Design Review Commission Report

Meeting Date: Thursday, August 6, 2015
(continued from July 2, 2015)

Subject: **711 Hillcrest Road (PL1507304)**
A request for an R-1 Design Review Permit to allow a new two-story single-family residence located in the Central Area of the City north of Santa Monica Boulevard. The Commission will also consider adoption of a Categorical Exemption, pursuant to the California Environmental Quality Act.

SHEET TITLE: (N) FRONT ELEVATION WITHOUT GATE PROJECT TITLE: 711 N. HILLCREST RD. BEVERLY HILLS, CA 90210	REVISION: _____ _____ _____ DRAW: F.P. SCALE: 1/8"=1'-0" DATE: 07-20-15 PROJECT NO.: _____
SHEET NO. A4.1

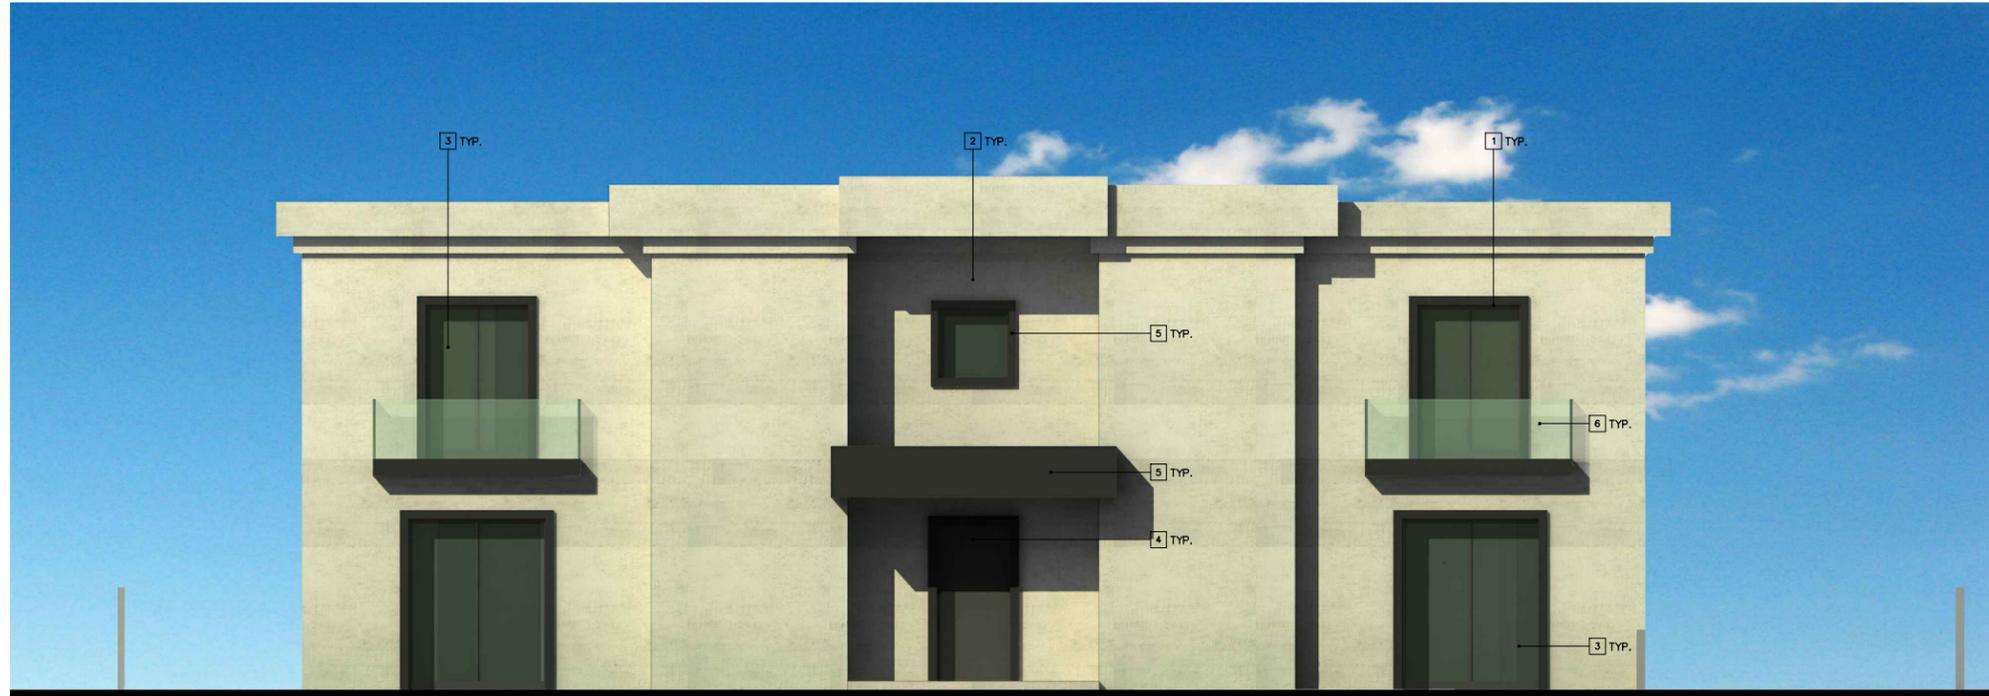
Based on a review conducted by the Urban Design Team, the design does not appear to respond adequately to the Commission's request for a complete redesign. The redesign still appears very boxy and the proposed green glass for the windows is more commercial office than residential. The landscaping plan while replacing the Camphor trees with Olive trees, is just lawn and bamboo at the base of the building with limited hedges on the side. At a minimum the Code requires that the areas of paving have an 18" to 3' high hedge along the sides which the plan lacks entirely. Staff feels that the design needs further refinement along with the proposed landscape plan and is recommending that the Commission hold the public hearing and provide the Applicant with design guidance for the project.

4. Fence and gate

The fence and gate have been eliminated.
